What Difference Does It Make?

The Glitch:

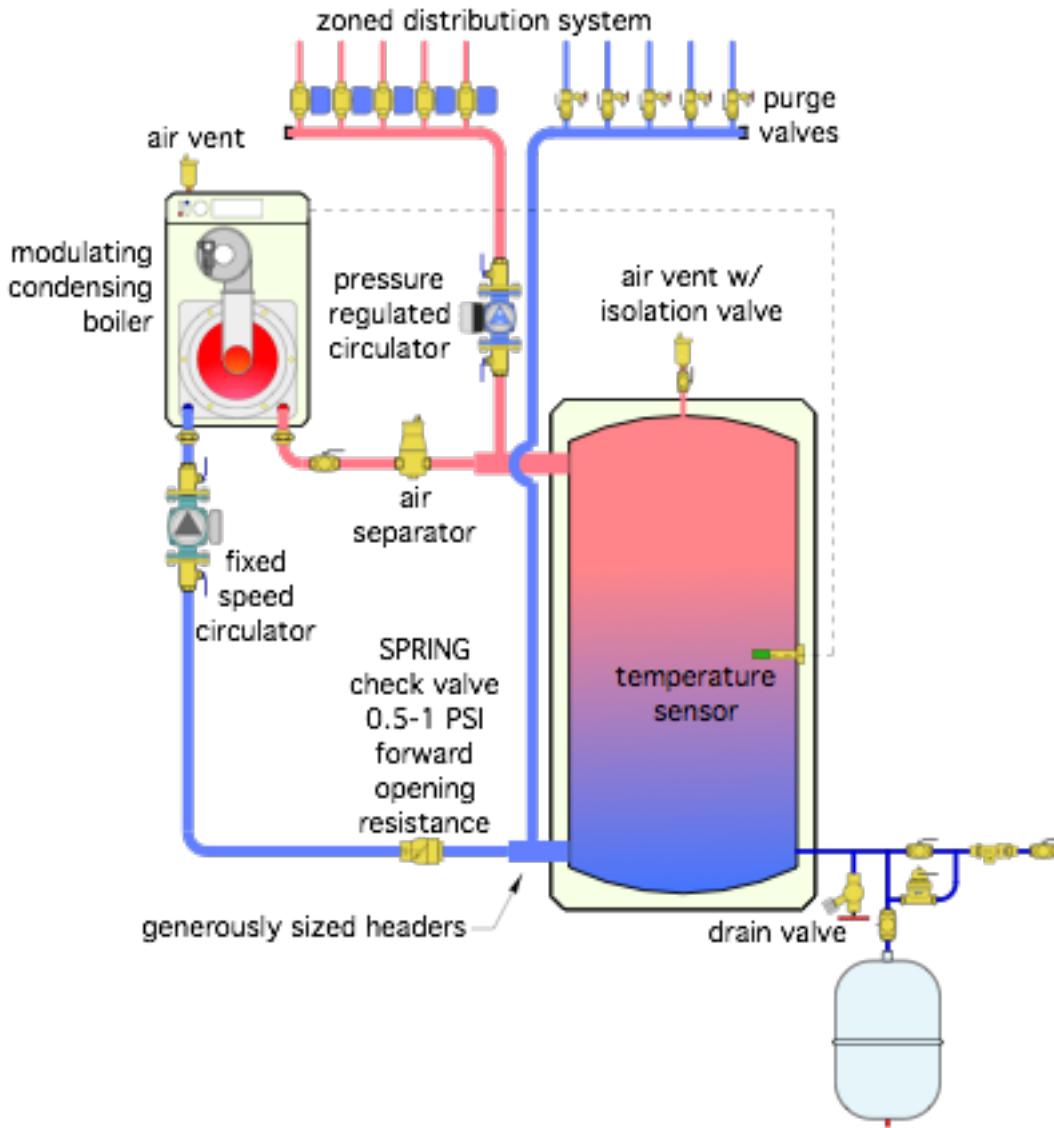
An installer decides to use a buffer tank between a mod/con boiler and a highly zoned distribution system. They select and install the buffer tank and other hardware as shown in figure 1. The boiler is programmed to turn on when any zone is calling for heat, and the temperature sensor at the top of the buffer tank drops to 120 °F. The boiler turns off when the temperature at that sensor reaches 140 °F, or if no zone is calling for heat. The load circulator turns on whenever any zone circuit calls for heat. Can you spot several errors or omissions in the proposed system?

Here're a dozen goof ups in the original configuration.

1. The sidewall connections on the buffer tank are located well down from the top of the tank, and well up from the bottom of the tank. This will leave the hottest and coolest water "stranded" in the tank, because the hottest water doesn't "want" to come down from the top, and the coolest water doesn't "want" to move up from the bottom.

2. The swing check valve in the boiler inlet pipe will not stop water returning from the load circuits from migrating through the boiler when it's off. This unnecessarily dissipates heat through the boiler enclosure and reduces the supply water temperature to the load circuit due to mixing at the upper tank header.

3. The pipe sizes entering the sidewall connections on the tank are not increase relative to the boiler and load circuit piping. Given the common practice of sizing piping in small hydronic systems for 4 feet per second velocity, the flow velocity entering the tank will be well above the suggest 2 feet per second limit.

4. The make up water system could work as shown, but any cool water entering the tank would mix with what is likely to be hotter water, which tends to disrupt temperature stratification.

5. The temperature sensor mounted at the top of the tank will tend to reach the temperature at which the boiler turns off before the water well below the sensor has reached this temperature. It would be better to located the sensor at the mid-height of the tank.

6. The drain valve will not allow water below the lower sidewall connect to be drained from the tank.
7. The fixed speed circulator on the distribution system does not provide differential pressure control as zone valves open and close. If a fixed speed circulator is used with

valve-based zoning, a differential pressure valve should be installed. Even better, use a variable speed pressure-regulated circulator and forget the bypass valve.

8. The piping between where the load circuit connects to the tank headers is longer than necessary. This will add head loss to the common piping path and decrease hydraulic separation between the circulators.
9. There are no purging valves on the return side of the zone circuits.
10. The boiler circulator should be pumping into, not away from, any mod/con boiler (or other heat source) that has a relatively high flow resistance.
11. There's not central air separator in the system.
12. There's no air vent to let trapped air escape from the top of the buffer tank.

The corrections are all shown in figure 2.
